**BID SET
12/10/2010
ADDENDUM
NO. 2**

**BUILDING
D**

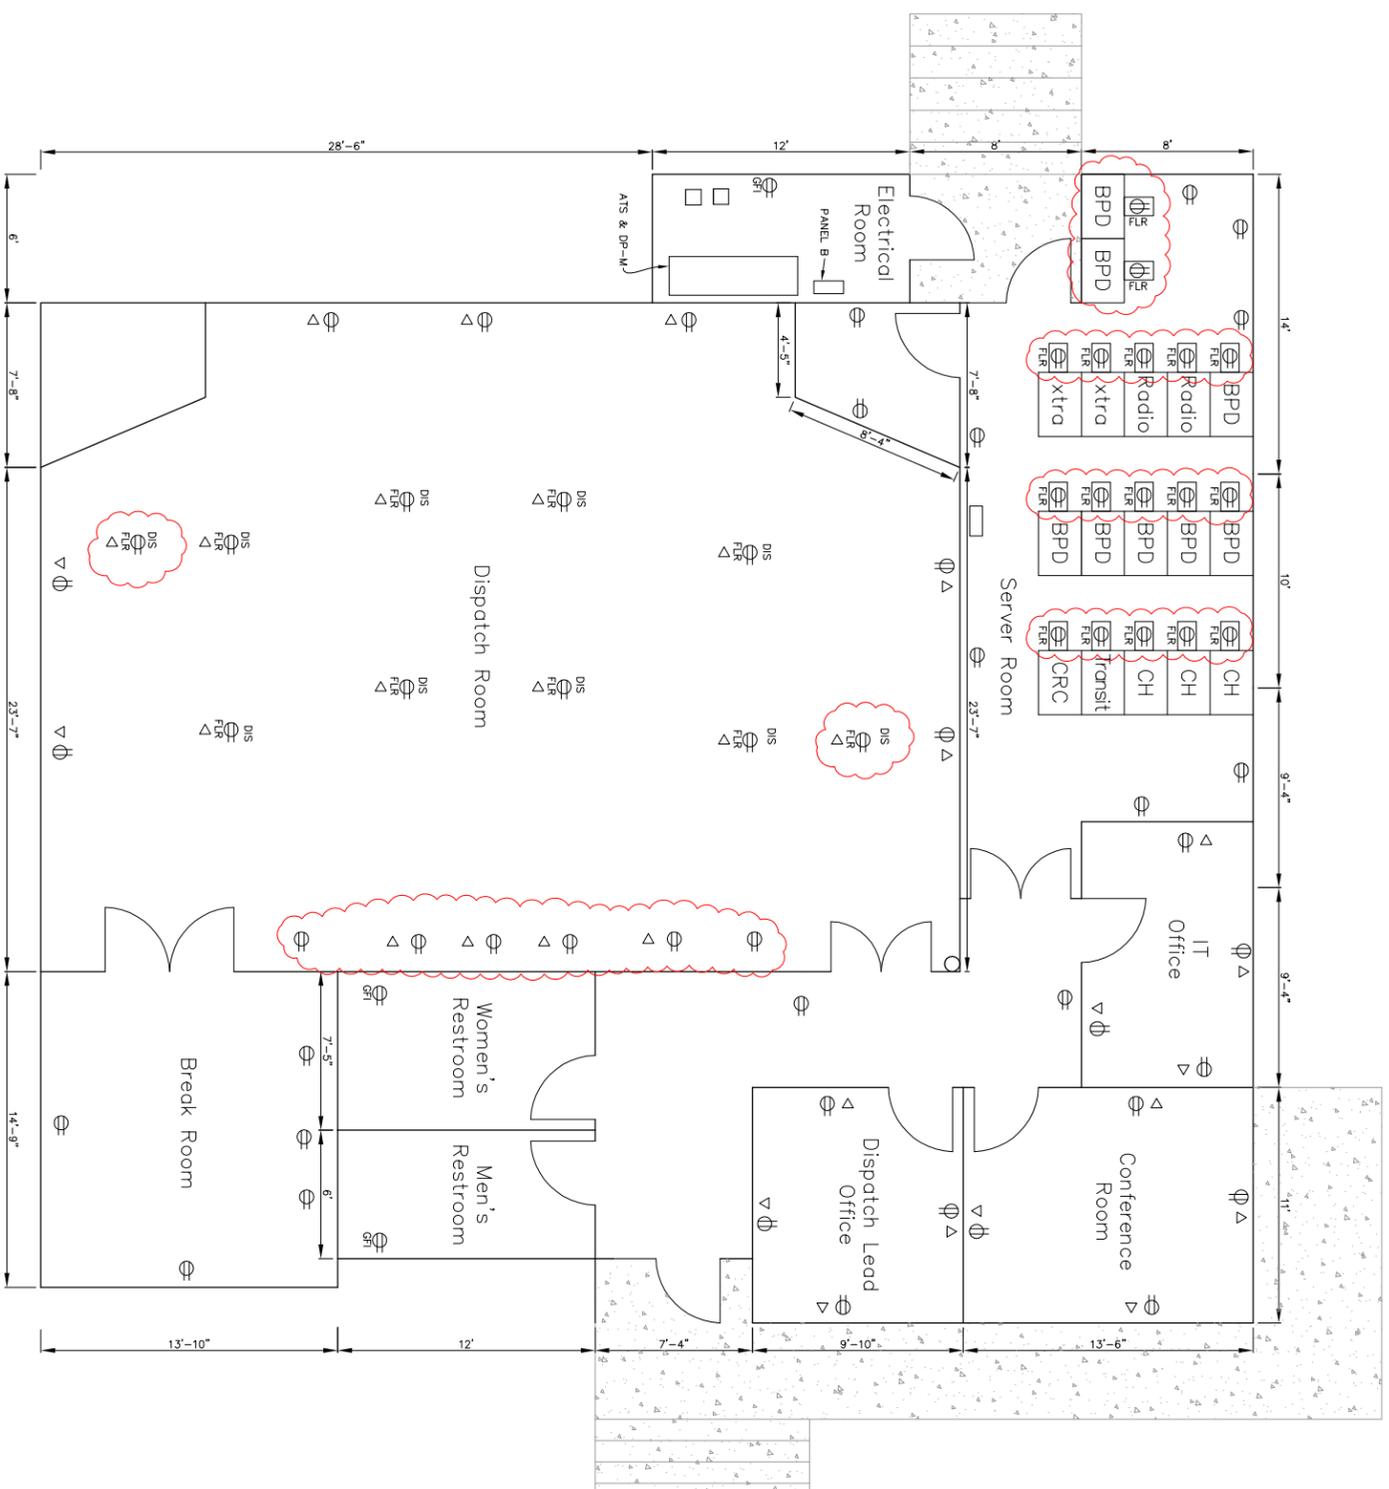
NOTE:
 PROVIDE COMPLETE WIRING TO THE ALL RECEPTABLES & DISPATCH OUTLETS WITH BALANCED LOAD CIRCUIT FROM DISPATCH PANEL-B. LOCATION AND ELEVATION OF REC. & OUTLETS ARE APPROXIMATE AND NEED FIELD VERIFICATION & COORDINATION WITH END USER PROVIDE ADDITIONAL REC & DISPATCH OUTLET IF REQUIRED PER CITY AUTHORITY.
 PROVIDE PANEL SCHEDULE COPY AT THE INSIDE DOOR OF ALL PANELS.
 TELEPHONE OUTLETS TO BE COORDINATED WITH END USERS.
 BREAK ROOM SHALL HAVE HOOK-UP REC. FOR MICROWAVE, REFRIGERATOR
 RESTROOMS SHALL HAVE HAND DRYER HOOK-UP.

REVISIONS ARE CLOUD MARKED
